# Conditional Use Permit Application Addendum

Yellowstone Pipe Line Company - Horizontal Directional Drill  
Under the Spokane River at Pipeline Mile Marker 1.3  
Spokane County, Washington

April 26, 2016  
Terracon Project No. 26145031

Subject: #Z16-048 SCUP Corrections Required

Proposed HDD and 15" Gravity Sewer Crossing

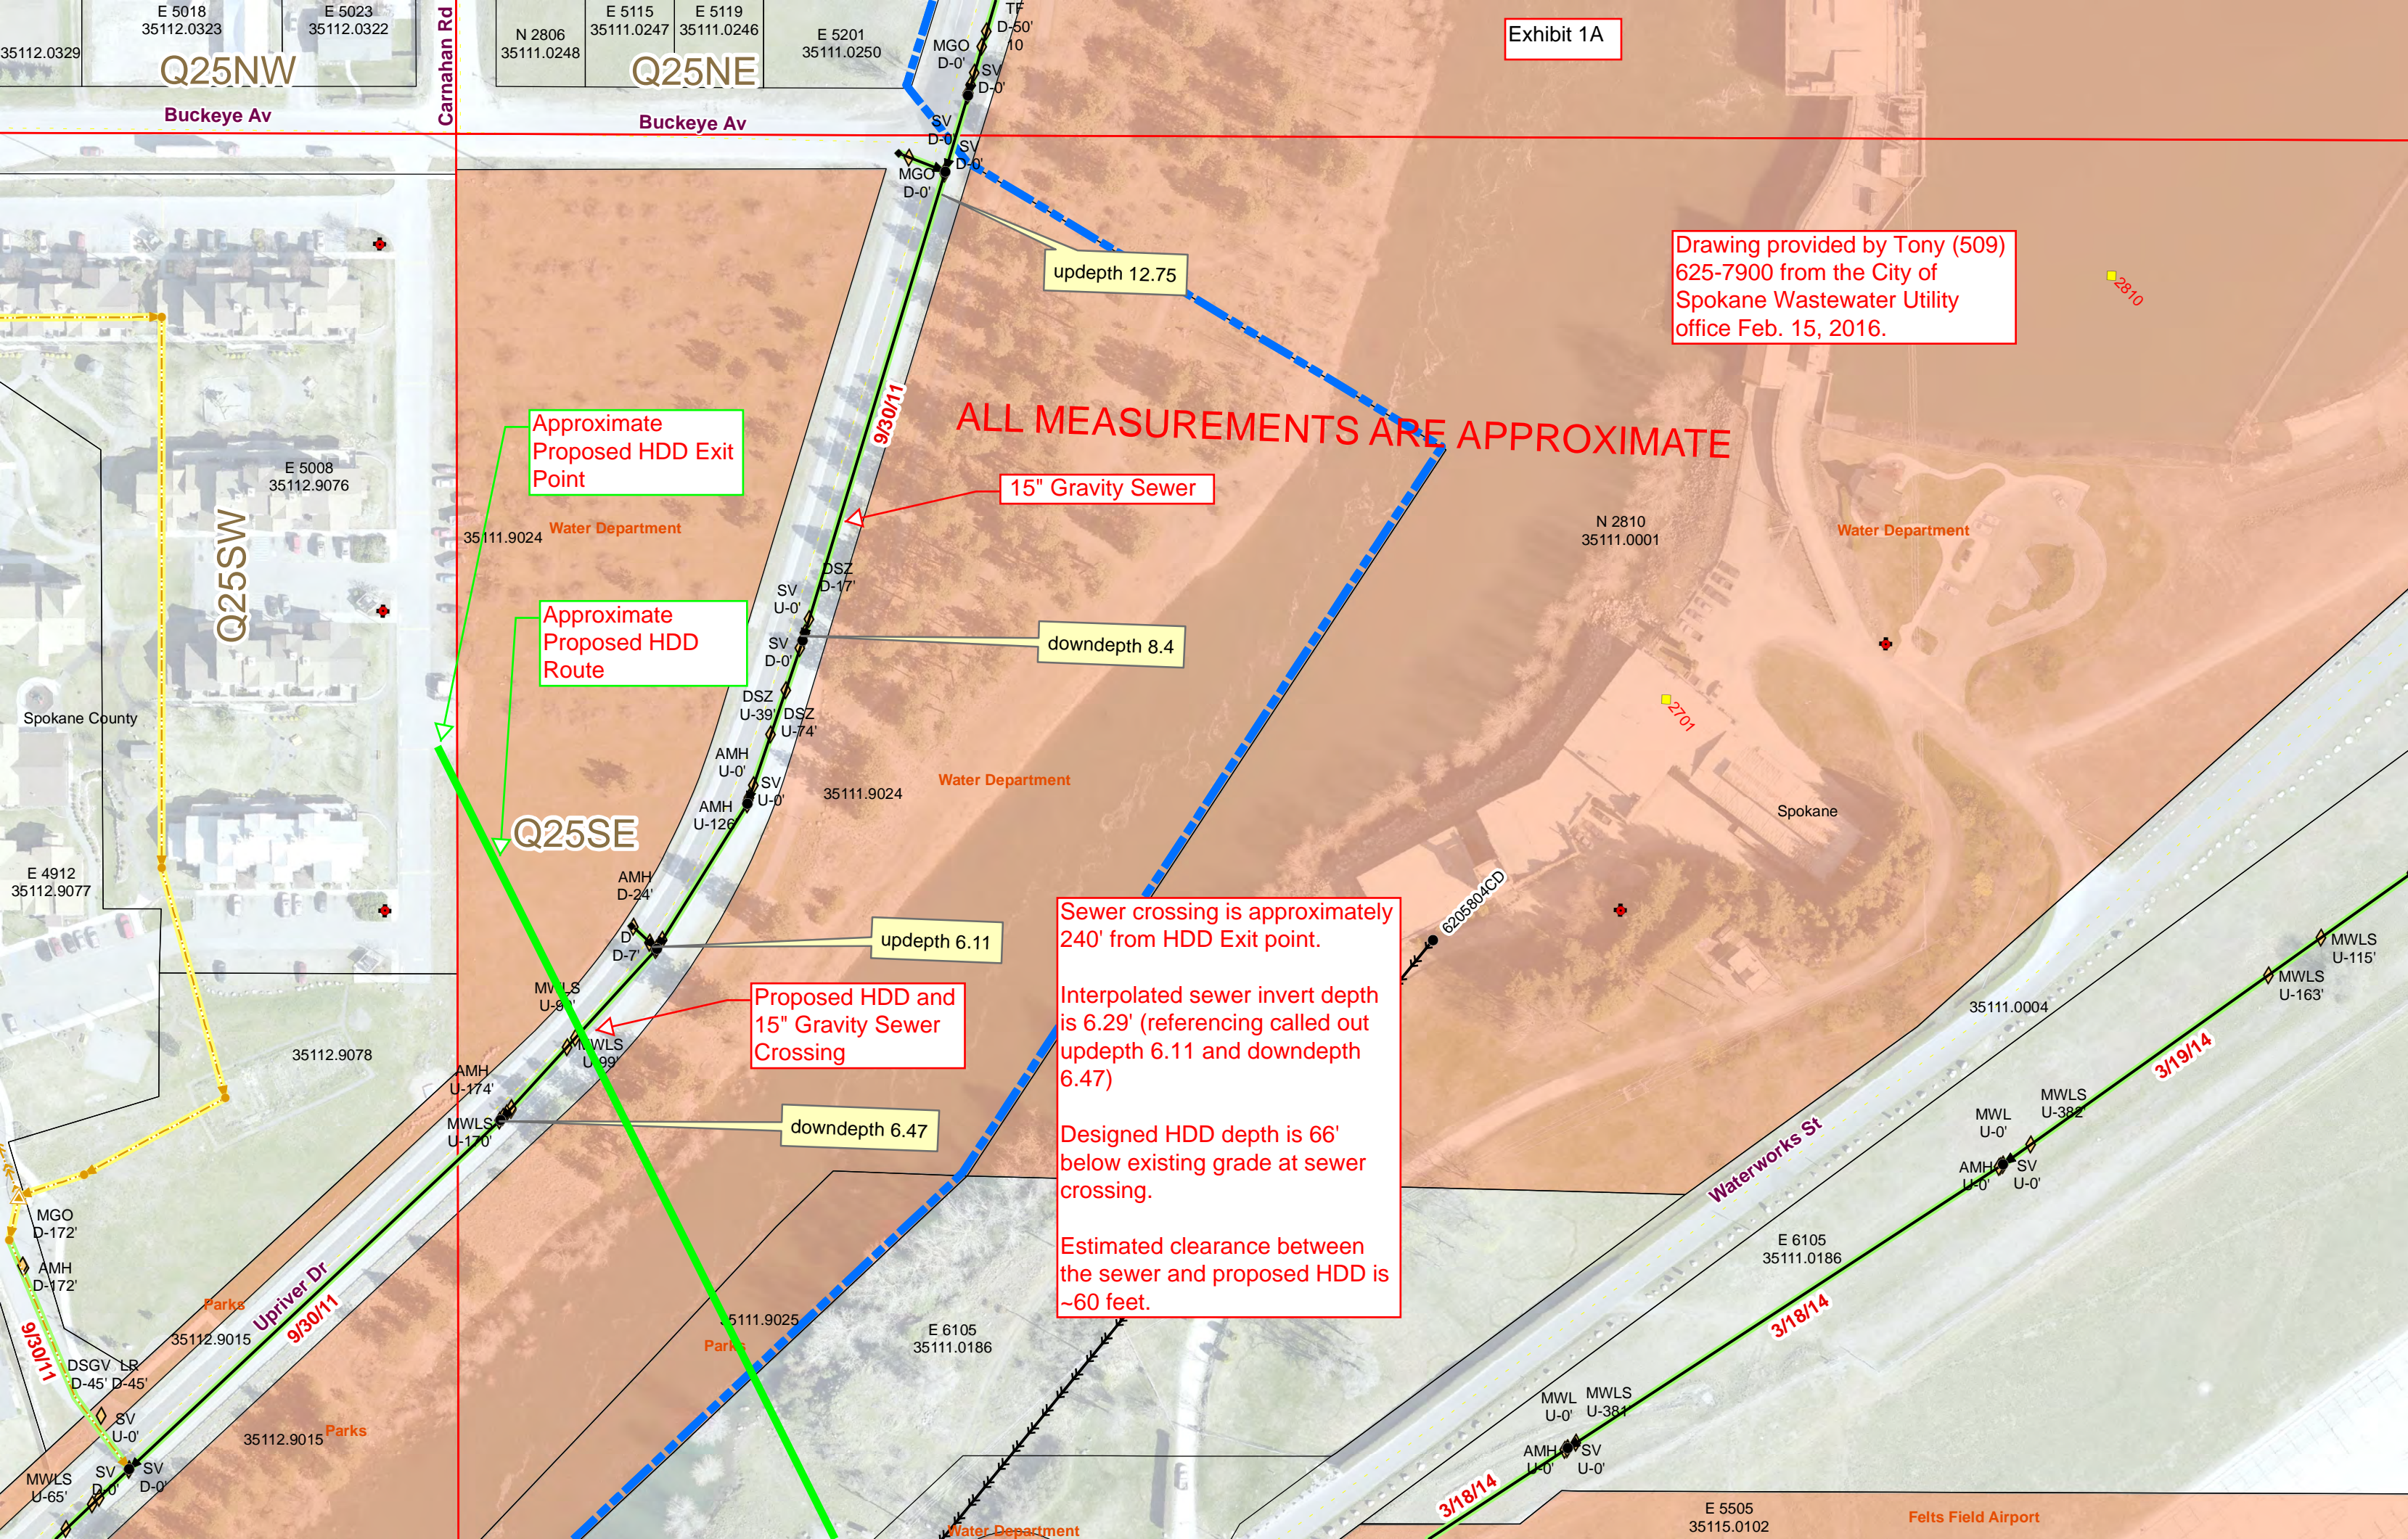
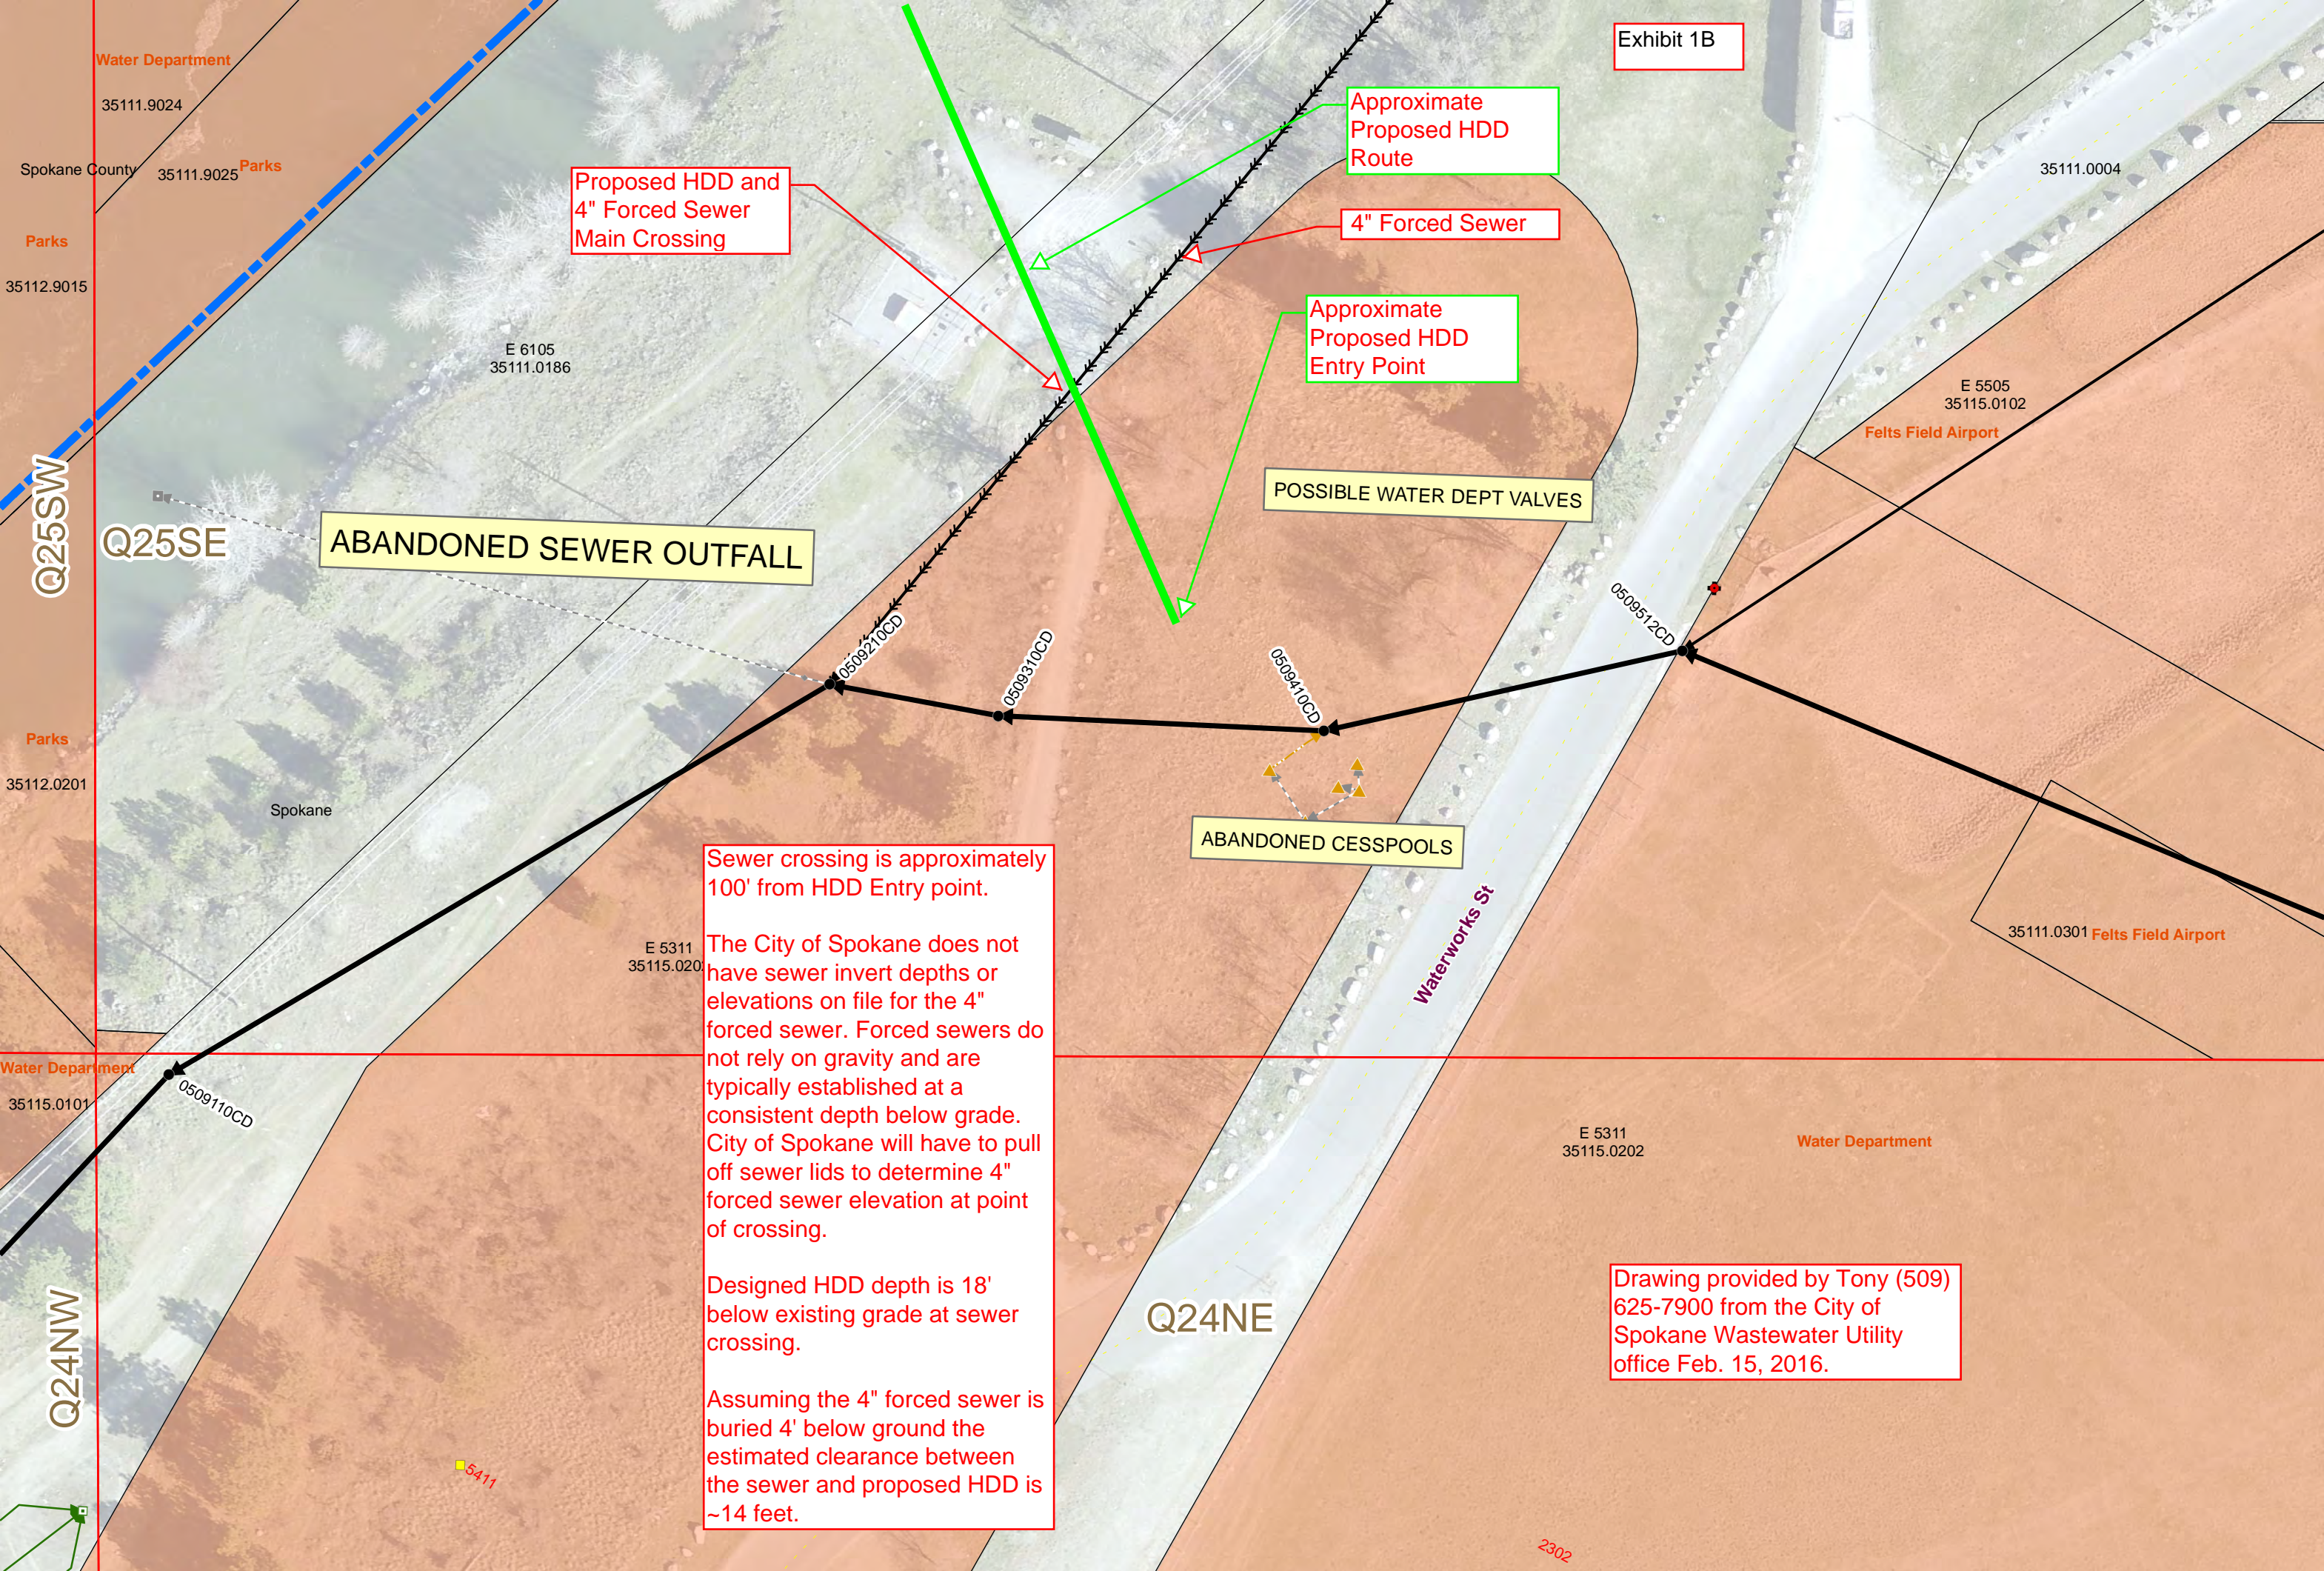
2. There is a 4-inch sanitary force main on the south side of the river and a 15-inch gravity sanitary main within the Upriver Drive right-of-way. Please show these and any other utility lines that will be crossed along with the invert elevations on the plans.

Sewer crossing is approximately 240' from HDD Exit point.  
Interpolated sewer invert depth is 6.29' (referencing called out updepth 6.11 and downdepth 6.47)

Designed HDD depth is 66' below existing grade at sewer crossing.

Estimated clearance between the sewer and proposed HDD is ~60 feet.

Sewer crossing is approximately 100' from HDD Entry point.

The City of Spokane does not have sewer invert depths or elevations on file for the 4" forced sewer. Forced sewers do not rely on gravity and are typically established at a consistent depth below grade. City of Spokane will have to pull off sewer lids to determine 4" forced sewer elevation at point of crossing.

Designed HDD depth is 18' below existing grade at sewer crossing.

Assuming the 4" forced sewer is buried 4' below ground the estimated clearance between the sewer and proposed HDD is ~14 feet.

**A VEGETATION REPLACEMENT PLAN**

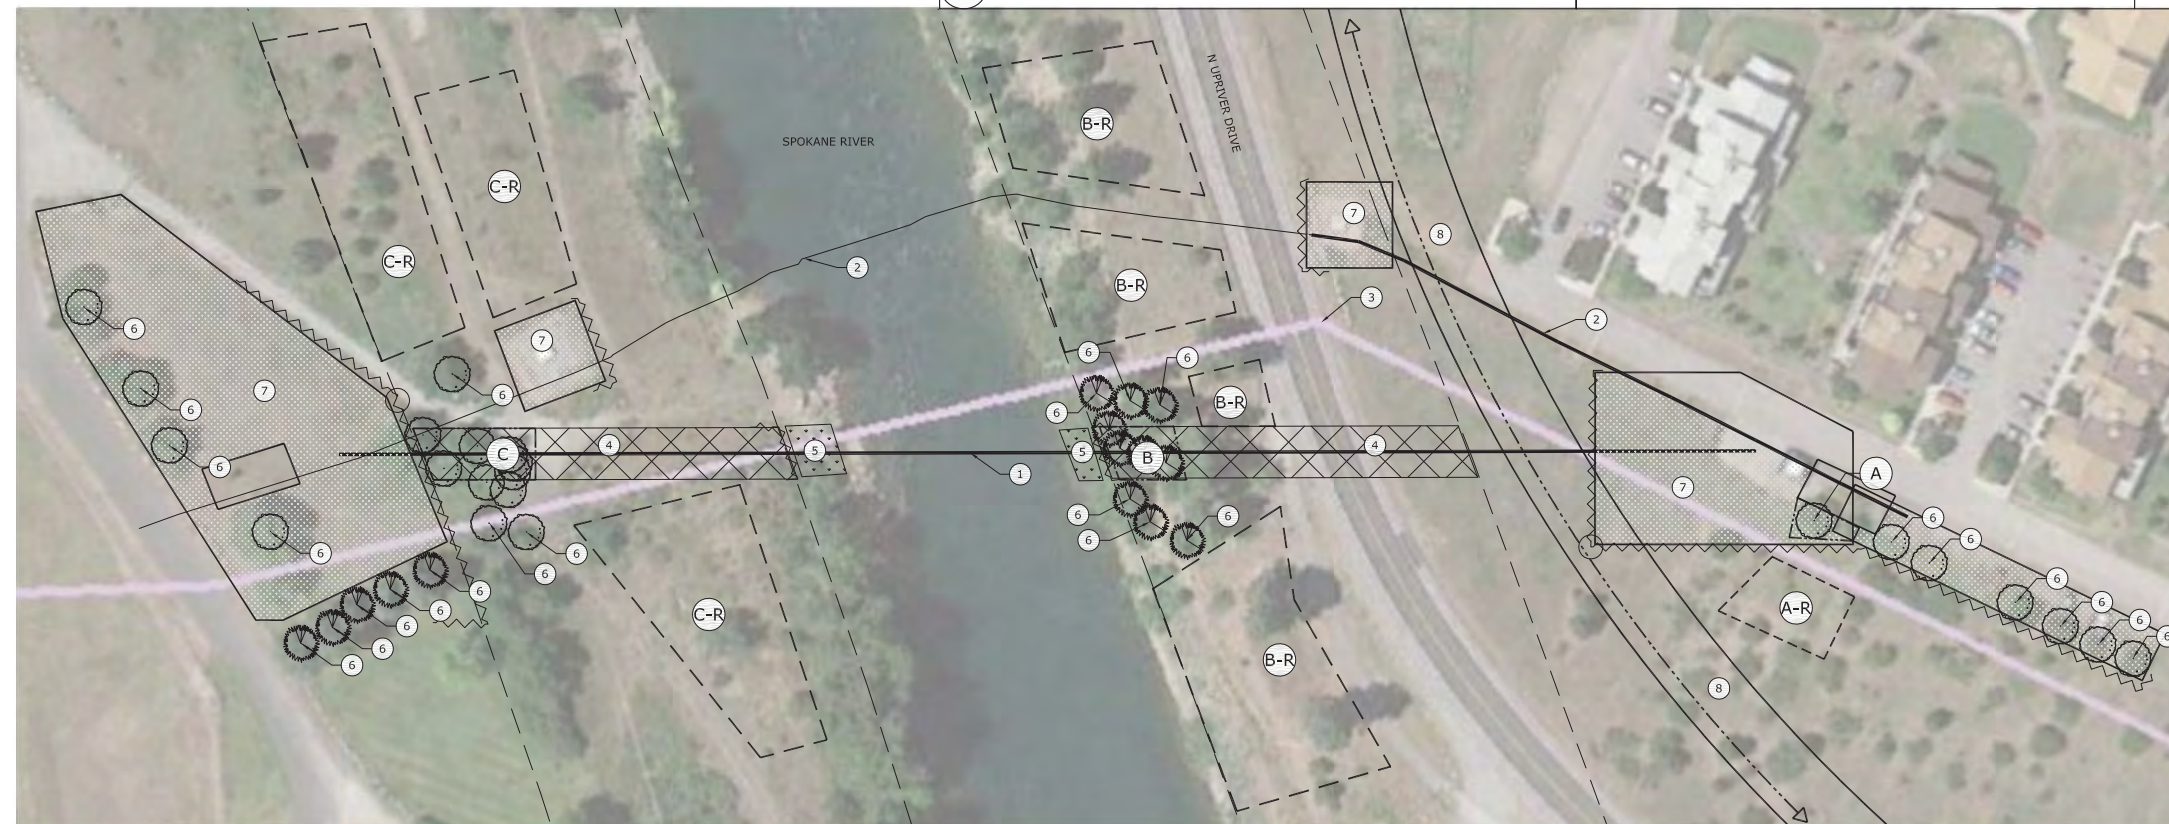
- 1. A Vegetation Replacement Plan will need to be submitted for review and approval as part of the application. Please review the Spokane Municipal Code Section 17E.060.230 Vegetation Conservation, Section 17E.060.260 Vegetation Replacement Plan, additional guidance can also be found in Section 17E.020.090.”*

- 1. Please submit an application for an Administrative Design Review at your earliest convenience.*
- 2. In order to help expedite this process you may want to have your landscape architect prepare a planting plan showing proposed native trees and vegetation in the full area of disturbance; the plans should include native plants arranged to mimic the natural vegetation patterns of the immediate surround area. Also please include information on irrigation, plant establishment and maintenance. Please show screening and fencing materials and avoid linear plantings around the perimeter of the protective fencing.”*

- 1. WDFW has reviewed the Yellowstone Pipeline proposal. Given that the pipeline project will result in permanent impacts to shoreline vegetation, WDFW recommends that the City request a shoreline restoration plan with native plants in order to mitigate these impacts. The restoration work can take place just outside of the area that must be visible for aerial inspections.”*

Applicant has prepared a Vegetation Replacement Plan (L-1) to mitigate removal of existing native and non-native trees and shrubs required by construction of the project. Applicant has identified three areas where native and non-native trees and shrubs will be selectively removed and those are listed in Table 1, below.

Applicant requests director's approval for the selective removal of native and non-native trees and shrubs identified on L-1 in order to comply with requirements for aerial inspection of the surface above the pipeline.

Applicant proposes to selectively remove identified native and non-native trees and shrubs in order to minimize impact to shoreline vegetative cover. Vegetative cover located directly adjacent to the Spokane River is identified on L-1 as callout #5. This shoreline vegetation is to remain.
